## TRANSMISSION CORPORATION OF ANDHRA PRADESH LIMITED

**Sub:** - System Improvement scheme for Up-gradation of existing 220/132 kV Rachagunneri to 400KV SS at Rachagunneri, Chittoor District with one 220KV SS Chervi Chittoor and one 132KV SS at Yerpadu to meet the load demand at proposed M/s Sricity SEZ located at Chervi, Chittoor Dt. - Request to include as agenda item for discussion in the forthcoming Standing Committee meeting - Reg.

**Sub:** - System Improvement scheme for Up-gradation of existing 132/33 kV Menakuru SS to 220/132/33 kV Menakuru SS by laying 220 kV DC line from proposed 400/220/132 kV Rachagunneri SS – Request to include as agenda item for discussion in the forthcoming Standing Committee meeting - Reg.

**Sub: "Constraints in 400 kV bays extensions at 400 kV Vemagiri S/s"**

CONNECTIVITY OF 275 MVA POWER TO 220KV SRI CITY SEZ RADIAL FROM 220KV SULLURPET SS & WITH CONNECTIVITY FROM 220KV RACHAGUNNERI

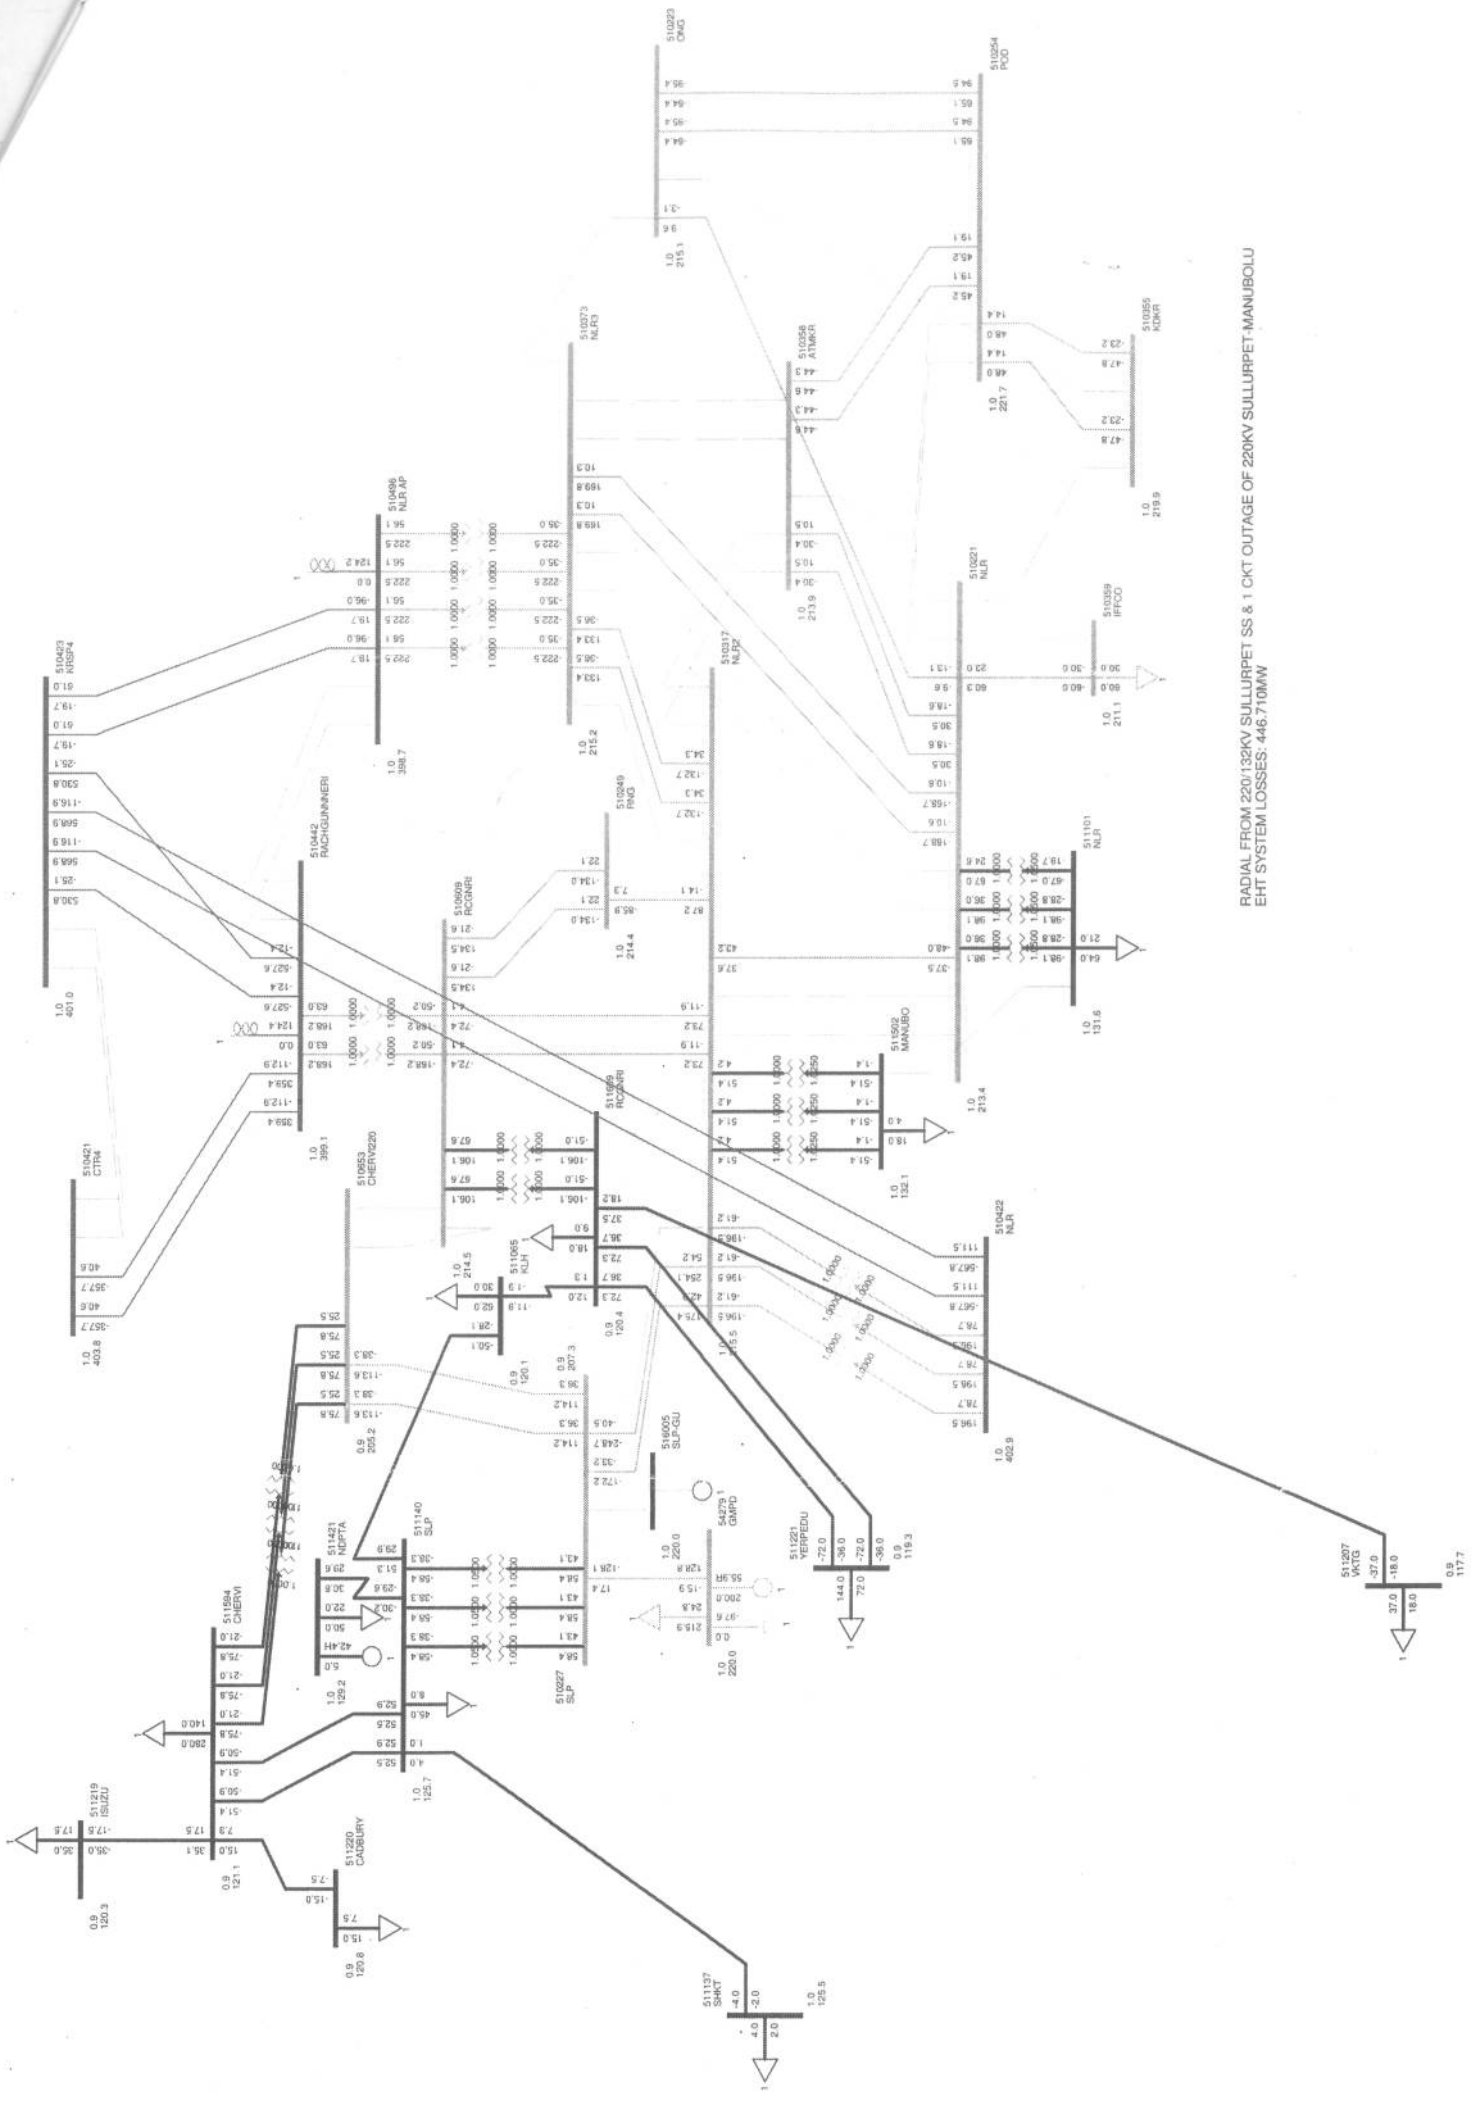
Accordingly System Studies were carried out by considering the field feasibility and Transmission requirement works for the year 2018-19, Hinduja evacuation scheme, Krishnapatnam evacuation scheme and wind & solar to be come up in the Ananthapur and Kurnool districts. The following dedicated Transmission scheme approved by APTRANSCO for providing power supply to M/s Sricity SEZ under VCIC scheme and also to meet the up-coming loads in and around Chittoor district is as follows:

1. Up-gradation of 220/132KV Rachagunneri SS to 400/220/132KV SS Rachagunneri with 2 x 315 MVA.
2. 400KV QMDC LILO of (45KM) 400KV SS Chittoor - 400KV APGENCO Krishnapatnam.
3. Up-gradation of 132/33KV Chervi SS to 220/132/33KV Chervi SS with 2 x 160 MVA.
4. Erection of 220 KV DC line (50KM) from 400KV SS Rachagunneri to 220KV SS at Chervi in Chittoor district
5. Erection of 220KV DC line (30KM) from 220KV SS Sulluripet to 220KV SS Chervi in Chittoor District.

6. Erection of 132/33KV SS at Yerpedu with 2 x 80MVA.
7. Erection of 132KV DC line (5KM) from 400/220/132KV SS at Rachagunneri SS to proposed 132KV Yerpedu SS.

### PRESENT ARRANGEMENT

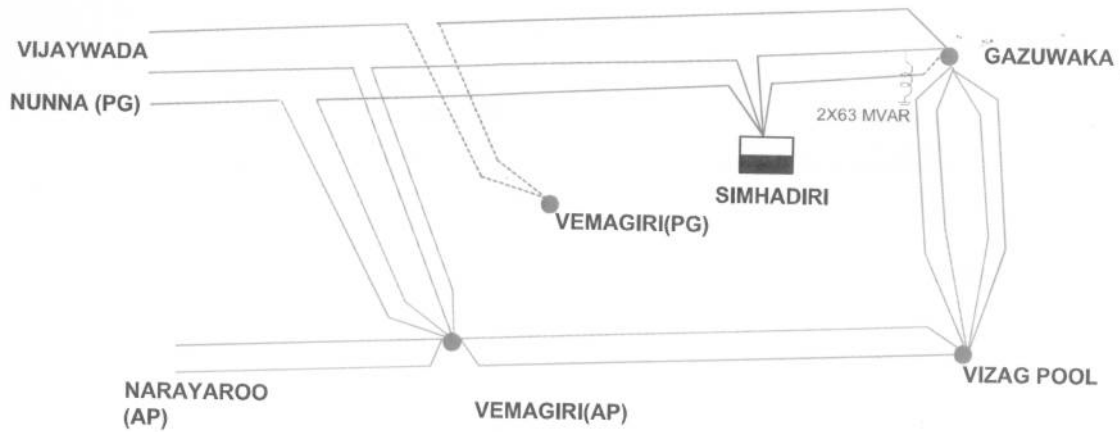
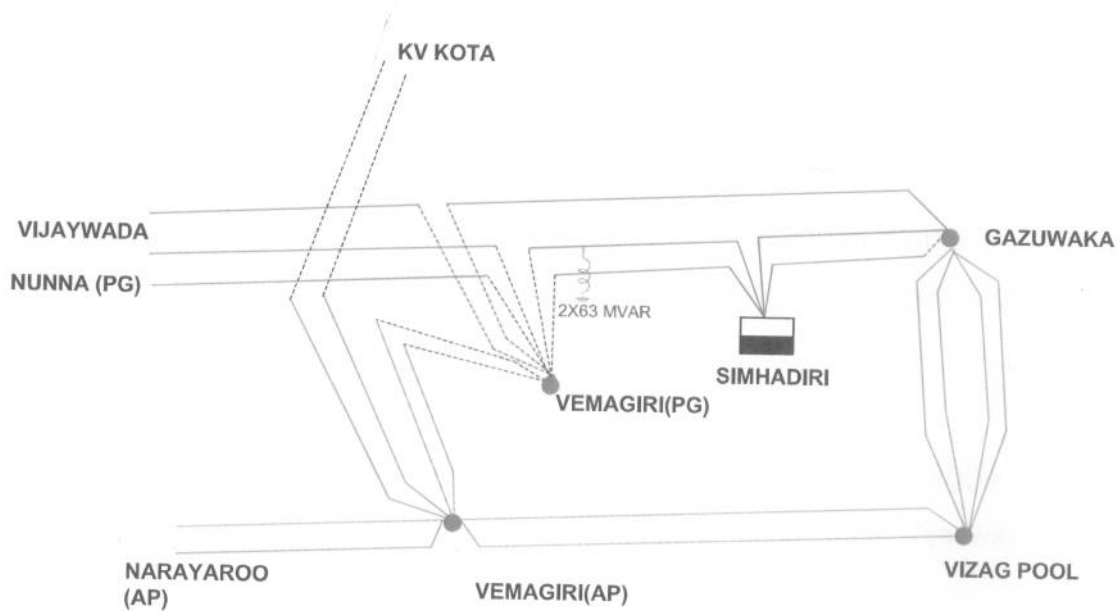
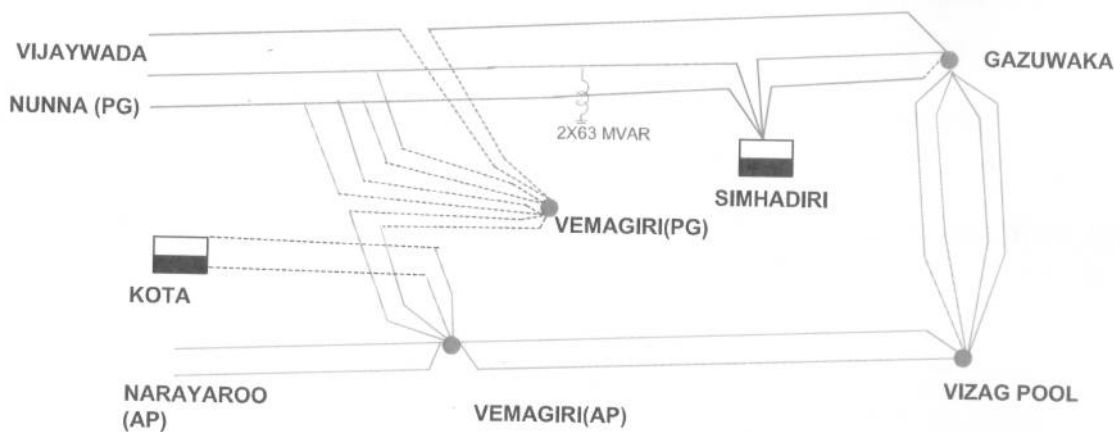
While carrying out field survey it was observed that interconnection of Simhadri-Vemagiri-II (PG) could be achieved by LILO in the LILO portion of Vijayawada -Simhadri 400kV D/c line at Vemagiri-I. This would result in reduction in line length of about 1.5km and there is no

change in the network configuration. The approved and proposed arrangement is shown in Exhibit-I. The proposal as received from site for the above modifications is also enclosed for your reference. It is requested that in-principle approval may be given and same may be informed in the next standing committee meeting.

S.No	AS PER SCHEME PROPOSED BY CC (VIDE IOM Dtd.16.01.15)	SCHEME PROPOSED BY SITE	JUSTIFICATION
1	LILO of both circuits of Gazuwaka/Simhadri-II- Vemagiri-I (AP) 400kV D/C line at Vemagiri-II(PG)	No change. However LILO of both the circuits is proposed in existing LILO portion of Vijayawada - Simhadri D/C line at Vemagiri 1 (AP).	From the comparison statement it is observed that there is no change in between scheme proposed by CC and site except the straightening of LILO. Reasons for not proposing the LILO is also explained in adjacent column.
2	Straightening of LILO of Vijayawada(Nunna) - Simhadri-II/Gazuwaka 400kV D/C line ( by disconnecting the LILO at Vemagiri-I(AP)), so as to make Vijayawada (Nunna) - Vemagiri-II 400kV D/C line.	Straightening of existing LILO of Vijayawada - Simhadri line is not proposed as Vijayawada - Vemagiri 2 (PG) and Simhadri - Vemagiri 2(PG) are achieved by LILO in the LILO portion of Vijayawada - Simhadri 400kV D/C line at Vemagiri 1(AP)	Further, from the topo study the following are observed 1. Location chosen by site for LILO at Sr.No.1 is nearer to Vemagiri (PG) by 1.5km approx. vis-a-vis to that of CC proposal.

3	Utilisation of one LILO D/c portion (of Gazuwaka/Simhadri-II - Vijayawada (Nunna) at Vemagiri I(AP) for KV Kota - Vemagiri-I(AP) 400kV D/C line.	No Change	2. Pockets of habitations are more in the scheme proposed by CC.Also, line alignment has to cross NH. 3. Considering the corridor availability due to real estate development in and around vemagiri area M/c provision is kept in the site proposal for the termination of lines Vijayawada & Simhadri D/C line at Vemagiri 2(PG).
4	Second LILO D/C portion (of Gazuwaka/Simhadri-II - Vijayawada (Nunna) at Vemagiri-I(AP)) to be extended to Vemagiri-II(PG)	No change
